BRIDGE DESIGN MEMORANDUM – DM0115

Re: SCDOT Seismic Design Specifications for Highway Bridges, Version 2.0
Revisions to Section 3, Section 6, Section 7, Section 8 and Section 9.

Figure 6.2 Oversized Drilled Shaft

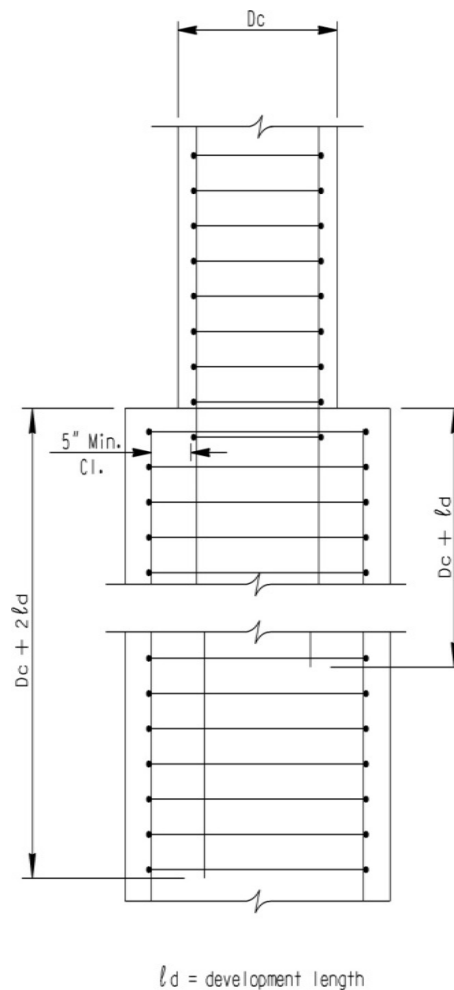
The key to forcing the plastic hinge above ground with the oversized drilled shaft is placing the transverse reinforcement in the shaft at a larger diameter than the column framing into the shaft. Providing a larger diameter of transverse reinforcement increases the area of confined concrete in the region. Oversized shafts shall be at least 24 inches larger than the diameter of the column framing into the shaft. Column longitudinal reinforcement shall extend into oversized shafts in a staggered manner as shown in Figure 6.2.

Figure 6.2 Typical and Oversized Drilled Shafts: Delete figure and replace it with the following:

Figure 8.4 Reinforcement for Column on Oversized Drilled Shaft

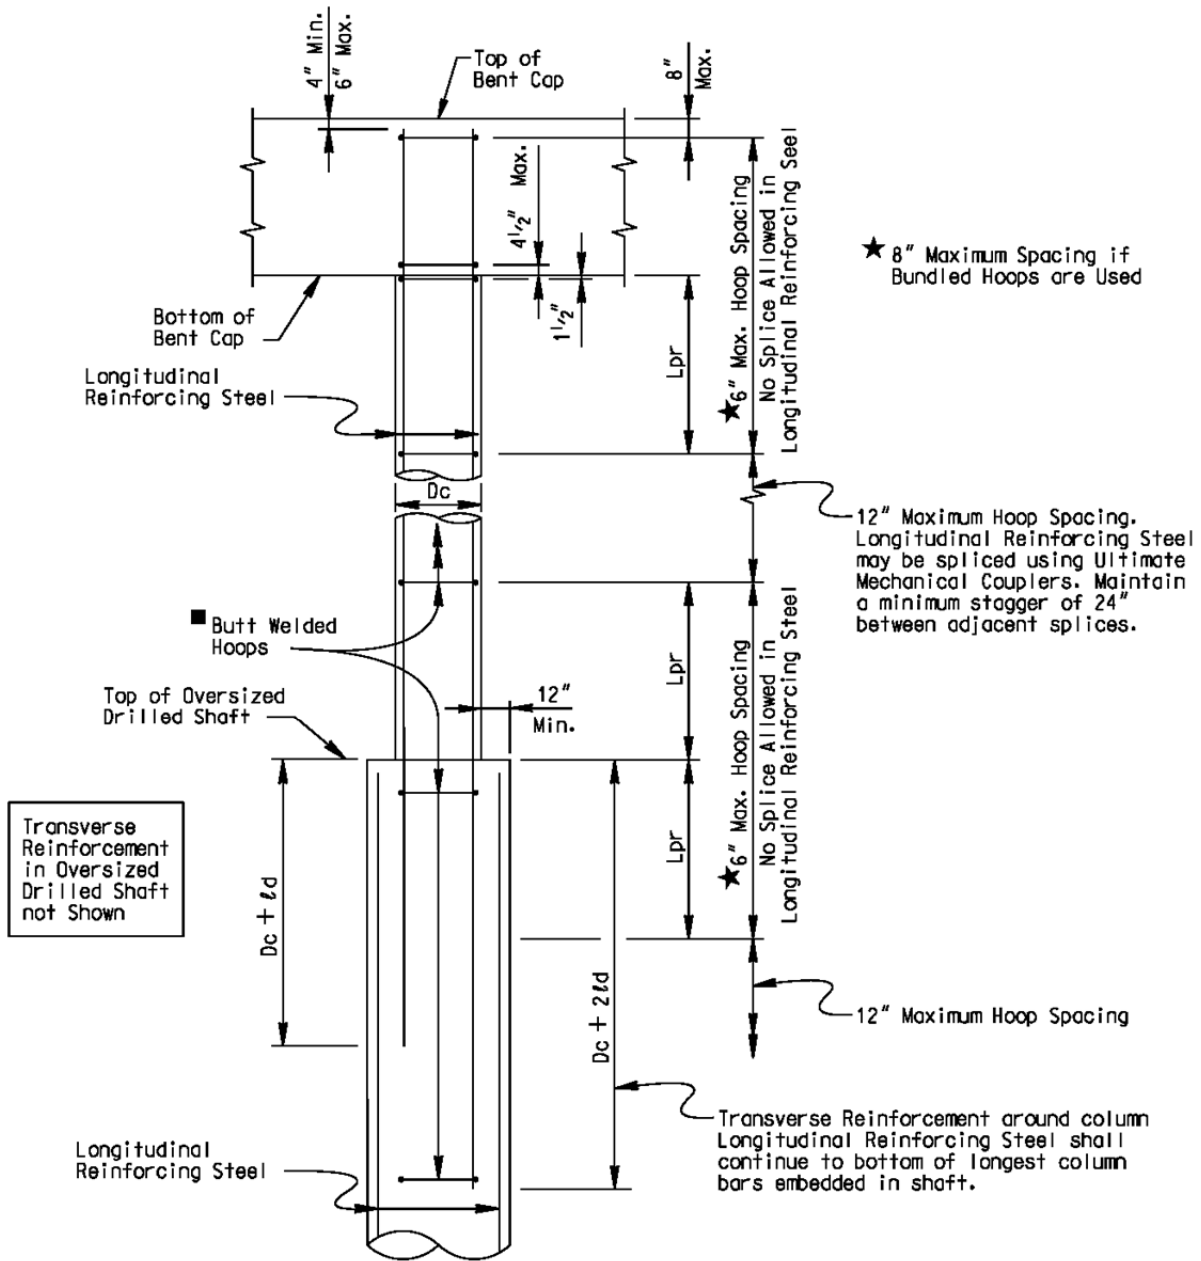
Longitudinal column reinforcement shall be extended into oversized shafts in a staggered manner with the minimum embedment lengths of $(D_c + l_d)$ and $(D_c + 2l_d)$ where D_c is the cross sectional dimension of the column and l_d is the tension development length of the longitudinal column reinforcement. See Figures 6.2 and 8.4.

Figure 8.4 Reinforcement for Column on Oversized Drilled Shaft: Delete figure and replace it with the following:

■ Hoops shall have butt welded splices. The minimum size shall be #19 (#6) and the maximum size shall be #25 (#8). To prevent the hoop weld splices from being located on the same vertical plane, the locations of the splices shall be staggered around the perimeter of the column by a minimum distance of 1/3 of the hoop circumference.

Note: Shaft transverse reinforcement does not have the same diameter as the column transverse reinforcement.
